# **Official Transcript of Proceedings**

## **NUCLEAR REGULATORY COMMISSION**

Title: Advisory Committee on Reactor Safeguards  
Thermal Hydraulic Phenomena Subcommittee

Date: Tuesday, May 5, 2020

Figure 1. High-Temperature Cladding Failure Threshold

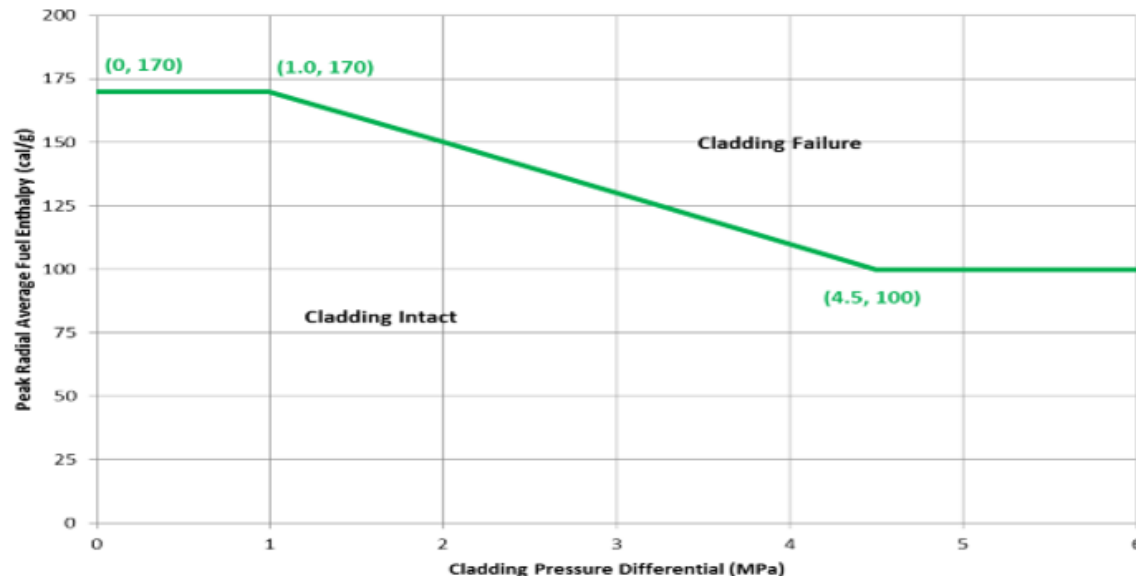
15 Based upon comments received, the  
16 application of the high temperature cladding failure  
17 curve which we just talked about was changed from all  
18 zero power scenarios to all prompt critical power  
19 scenarios to be more consistent with the empirical  
20 database. So the way this is now worded was if you're  
21 at prompt critical excursion, you use Figure 1. If  
22 you're non-prompt, then you use your DNB, CPR thermal  
23 design limits to estimate cladding failure. Any  
24 questions?

For prompt critical scenarios which experience a prolonged power level following the prompt pulse, fuel cladding failure is presumed if local heat flux exceeds thermal design limits (e.g., departure from nucleate boiling and critical power ratios).

For non-prompt critical excursions, fuel cladding failure is presumed if local heat flux exceeds thermal design limits.

# **Separate PCMI Failure Thresholds**

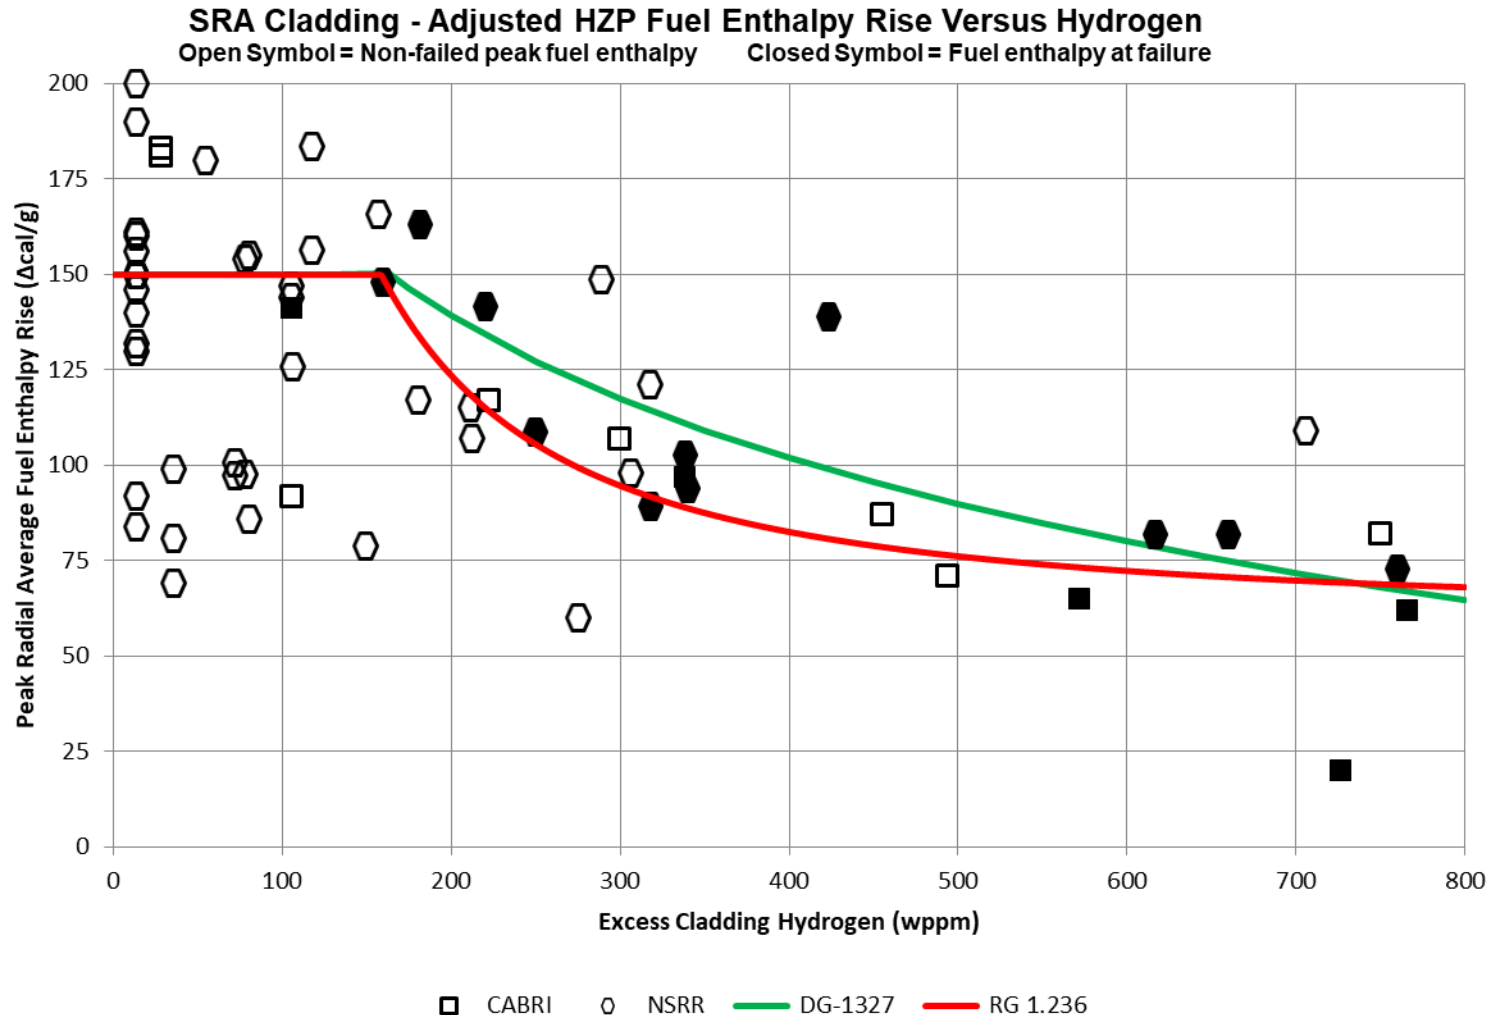
6 So let's get into a comparison of these  
7 four curves. This plot shows the SRA high temperature  
8 cladding failure from the DG-1327 along with a revised  
9 curve from Reg Guide 1.236 and the supporting  
10 database. In response to comments, the algebraic form  
11 of the failure correlation was changed. The new  
12 correlation exhibits a steeper decline showing a  
13 higher sensitivity to initial hydrogen content but  
14 then a saturation effect.

15 To provide regulatory stability, the staff  
16 elected to use a more conservative fit as opposed to  
17 the prior best estimate fit of the failure data. Best  
18 estimate curves are susceptible to constant change as  
19 new data becomes available. And as we started in  
20 2007, as more data became available, the staff found  
21 themselves redrawing the curves, trying to reestablish  
22 a best estimate fit.

8 So we expect more data to be available as  
9 we move forward, and we wanted to design these curves  
10 and draw these curves so it was more likely that the  
11 new data would confirm the continued applicability of  
12 the curve as opposed to necessitating changes to the  
13 curve because it was found to be non-conservative. So  
14 with regulatory stability in mind, we move from a best  
15 estimate fit to more of a lower bound drawing of the  
16 curve.

# Impact of Barrier Liner

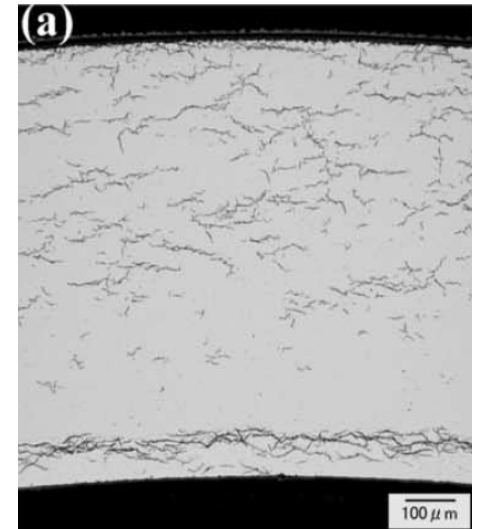
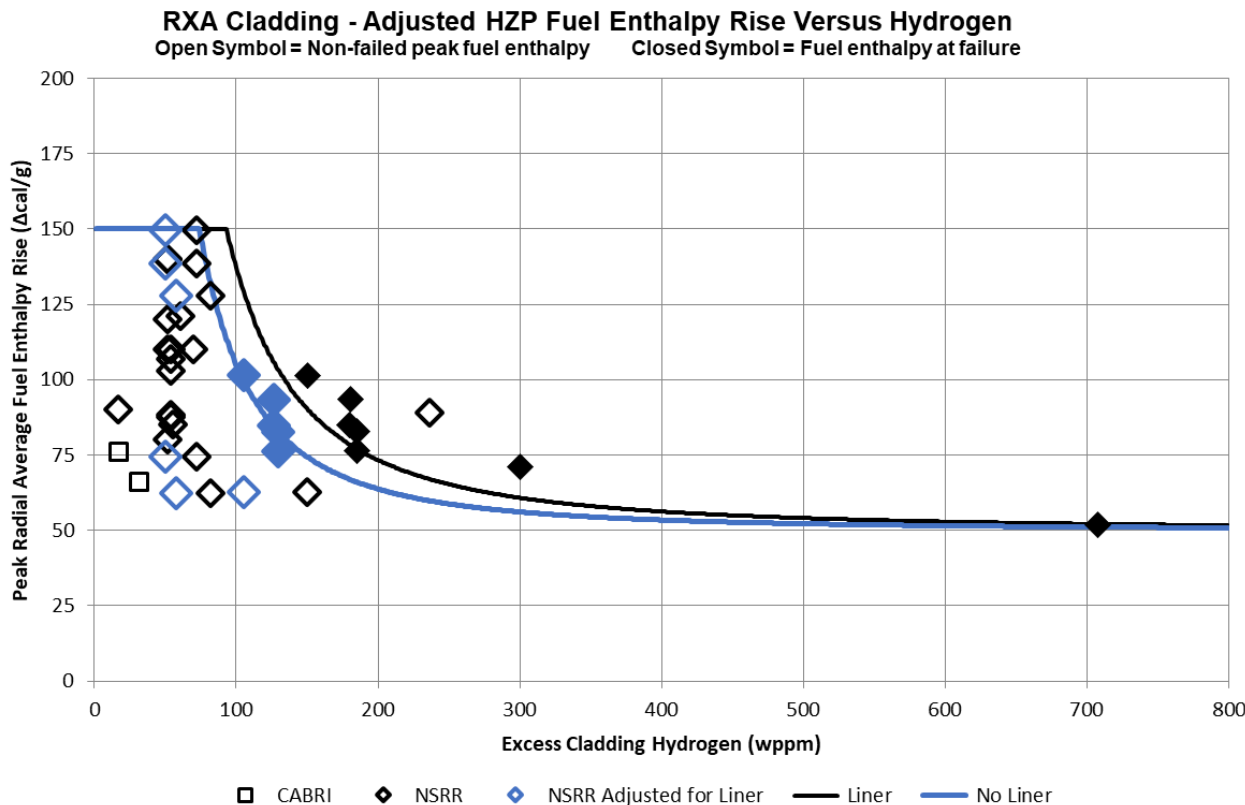
19 So maybe we move on to -- also, we're  
20 sticking with PCMI but moving into a different topic.  
21 We're getting into the impact or the potential impact  
22 of barrier lining on the application of PCMI failure  
23 thresholds. So in response to numerous fuel rod  
24 failures during normal operation in the BWR fleet in  
25 the '70s and '80s, the industry developed barrier

1 percent of the hydrogen in the barrier lining. Using  
2 the scale test results, the staff developed RXA PCMI  
3 cladding failures for both fuel rod types with and  
4 without barrier cladding. Are there any questions?

16 And if plants were to move away from  
17 zirconium liner, then they wouldn't have that second  
18 benefit, and thus at the same excess hydrogen level  
19 would have a higher impact on the cladding ductility,  
20 hence the shift in the curve. Okay. We'll go to the  
21 next slide. Now we're getting into a different agenda  
22 topic which is the hydrogen models.
